**From:** [Hemann, Joseph](#)  
**To:** [Rodriguez-Luccioni, Hector](#)  
**Cc:** [Struckmeyer, Richard](#); [Herrera, Tomas](#); [Gonzalez, Hipolito](#)  
**Subject:** RE: DRS Sustainment 4th Request for Additional Information  
**Date:** Thursday, April 16, 2015 8:46:20 AM  
**Attachments:** [ES6510\\_F.pdf](#)

**From:** Rodriguez-Luccioni, Hector [<mailto:Hector.Rodriguez-Luccioni@nrc.gov>]  
**Sent:** Tuesday, March 17, 2015 11:38 AM  
**To:** Hemann, Joseph  
**Cc:** Struckmeyer, Richard; Gonzalez, Hipolito; Herrera, Tomas  
**Subject:** DRS Sustainment 4th Request for Additional Information

**DWG NO. ES6510**

## SPECIFICATION CONTROL DRAWING

-01 MARKING 1/  
FIGURE 2

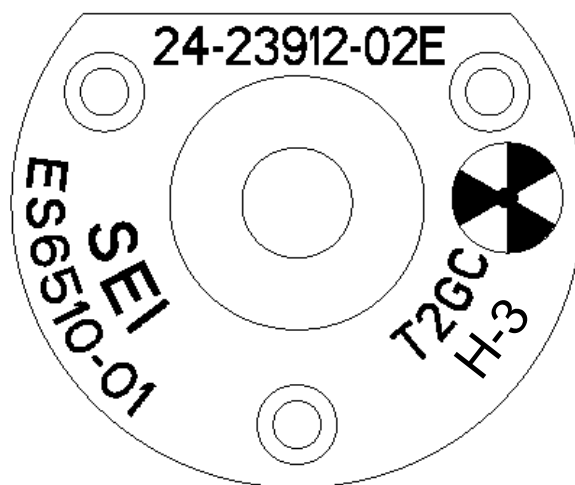
As part of the review process it is required that the NRC approves the label DRS will use on the device. Please submit a drawing of how this label will look like and the information that will be on the label by COB Wednesday, April 15, 2015. In addition include the new label in your amendment request regarding the Sealed Source and Device Registration certificate.

In our letter dated March 3, 2015, we requested a label that identifies the byproduct material in the product (Tritium, H-3) as required by 10 CFR 32.22(a)(2)(x). In your letter dated May 10, 2015, you provided a drawing of the label and a picture of the device assembly with markings. In your letter you stated that the label and markings include the letters "T2GC," which identifies the byproduct material and radioactivity level per ANSI/HPS N43.4-2000. After reviewing your response we concluded that "T2GC" cannot be considered as an identification of the byproduct material on the device. People using this device will not know that the device contains tritium unless they read the ANSI standard. Please provide a label that identifies the byproduct material by using the wording "H-3" or "Tritium."

1/ -01 MARKING WITHOUT “H-3” IDENTIFIER IS NOT FOR NEW  
PROCUREMENT AFTER 23 APRIL, 2015.

-01 MARKING WITH “H-3” IDENTIFIER IS FOR NEW  
PROCUREMENT AFTER 23 APRIL, 2015.
